Comments provided by Hawkins / Brown and Buro Happold 4/9/23		Our ref: HGY/2023/1043 Contact: Samuel Uff Date: 18/08/2023
Town and Country Act 1990 (As amended)		
Location:	Civic Centre High Road Wood Green London N22 8ZW	
Proposal:	Redevelopment of the existing rear car park for the erection of a three storey building (plus roof enclosure) comprising of Class E floorspace; 2 x two storey links; creation of central courtyard; parking and landscaping; and refurbishment and external alterations of the existing Civic Centre and offices, including alterations to entrance facade and fenestration; and associated works

Carbon Management Response 18/08/2023

Cycle facilities

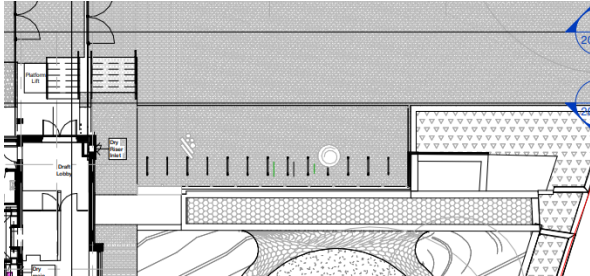
- The submitted cycle parking plans are not sufficient in detail to demonstrate they will be secure, and sheltered, guarantee easy access to lock a bike safely (whilst locking), and will encourage staff to cycle. It is not clear what the layout of cycle parking is, and whether the Sheffield stands will be located in a secure space.
